## 7.6 All Other Instrumentation Systems Required for Safety

The information in this section of the reference ABWR DCD, including all subsections, tables, and figures, is incorporated by reference with the following departures and supplements.

Figure 7.6-4a Basic Configuration of a Typical Neutron Monitoring System Division

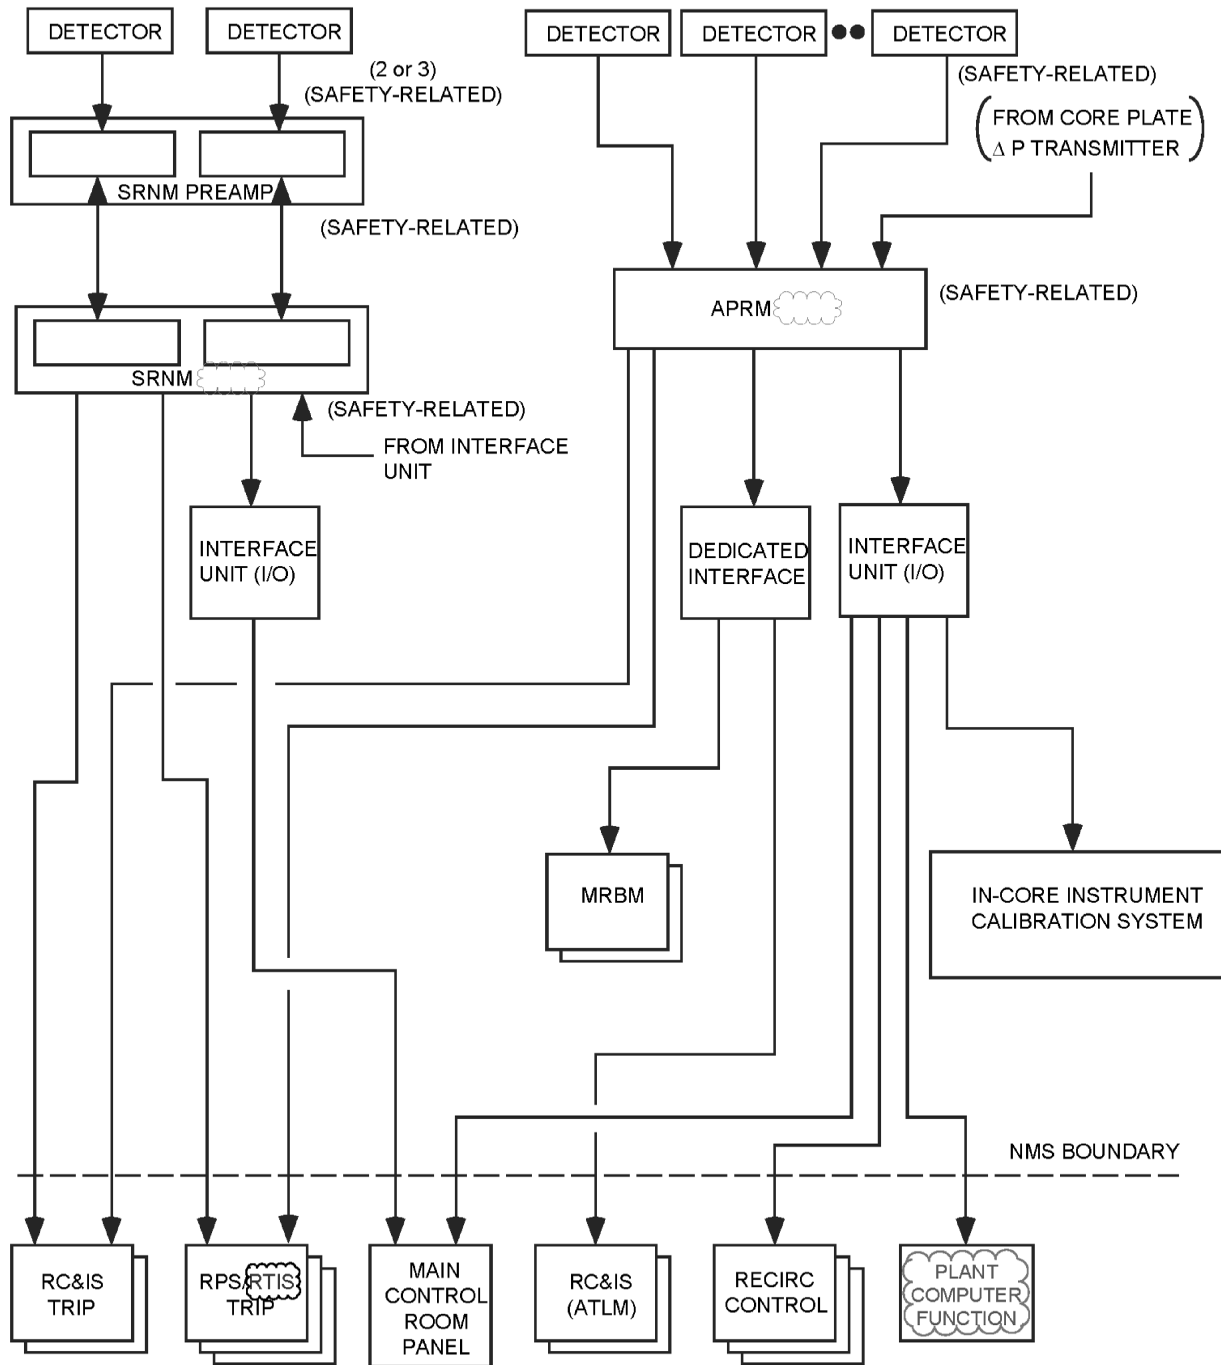
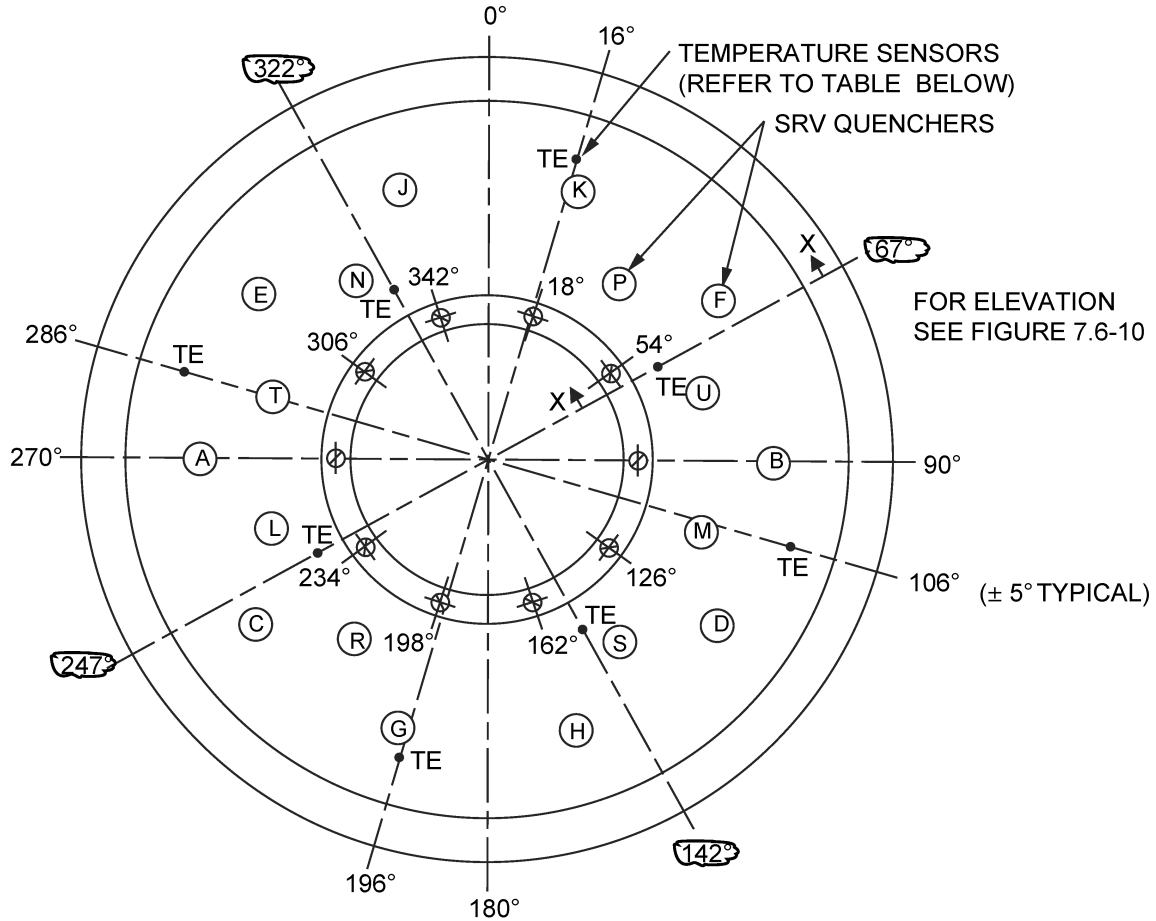
STD DEP T1 3.4-1 (Table 7.6-5 and Figures 7.6-1, 7.6-2, 7.6-4a)

*The purpose of the Neutron Monitoring System (NMS) is to monitor power generation and, for the safety function part of the NMS, to provide trip signals to the Reactor Protection System (RPS) to initiate reactor scram under excessive neutron flux (and power) increase condition (high level) or neutron flux fast rising (short period) condition. The NMS also provides power information of operation and control of the reactor to the Plant Process Computer System (PCS) Functions (PCF) and the rod block monitor. A block diagram showing a typical NMS division is shown in Figure 7.6-4a. The operating ranges of the various detectors are shown in Figure 7.6-4b.*

Figure 7.6-9 Instrumentation Location Definition for the Suppression Pool Temperature Monitoring System

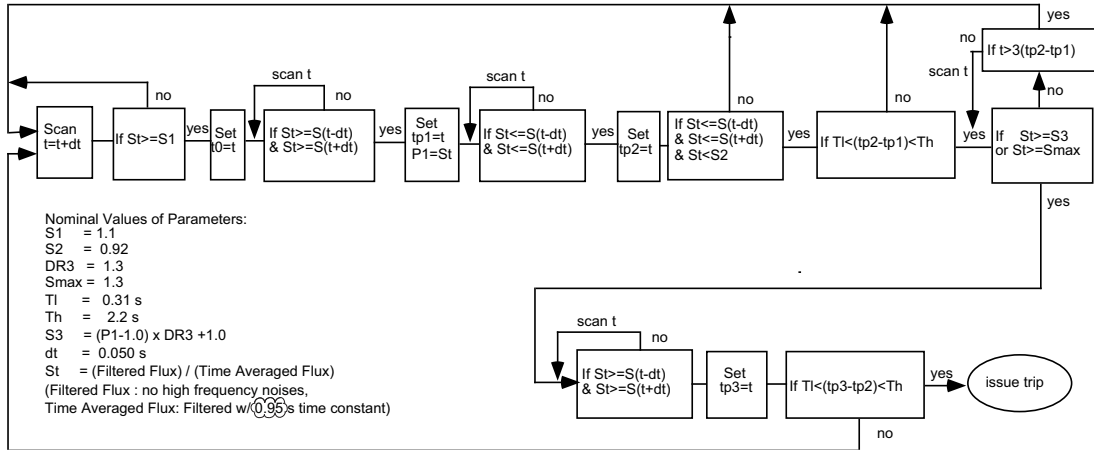
STD DEP 7.6-3 (Figures 7.6-9, 7.6-11)

The SPTM System configuration is shown in Figures 7.6-9 and 7.6-10. There are eight temperature circumferential sensor locations (Figure 7.6-9), which are chosen based upon the following considerations:

Figure 7.6-14 OPRM Logic

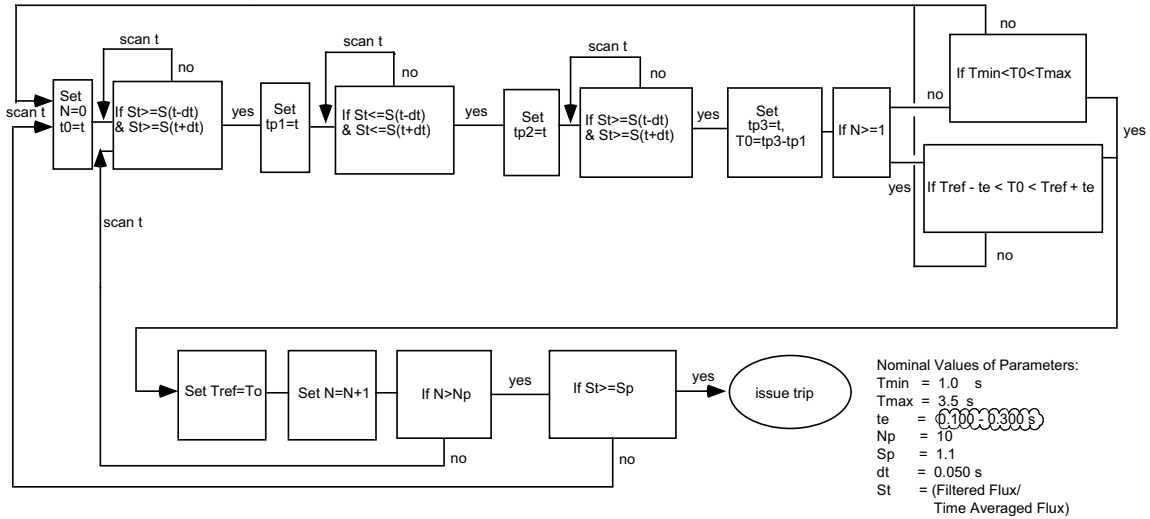
STD DEP 7.6-1 (Table 7.6-2 and Figures 7.6-2, 7.6-14)

For the OPRM trip function, the response signal of any one OPRM cell that satisfies the conditions and criteria of the trip algorithm will cause a trip of the associated OPRM channel. Figure 7.6-14 illustrates the trip algorithm logic. ~~The OPRM trip function does not have its own inoperative trip for insufficient number of total LPRM inputs in the channel. It follows the APRM's inoperative trip of insufficient number of LPRMs.~~ The OPRM function has its own inoperative trip when the channel has less than the required minimum operable cells, **when** there is an OPRM self-diagnostic fault, **when** the APRM instrument watchdog timer has timed out, or if there is a loss of power to the APRM instrument.

$T_{\min}=1$  s,  $T_{\max}=3.5$  s,  $\pm t_{\text{error}}=0.15$  s **[0.100 - 0.300s]**,  $N_P=10$ .  
 (For details see Figure 7.6-14).
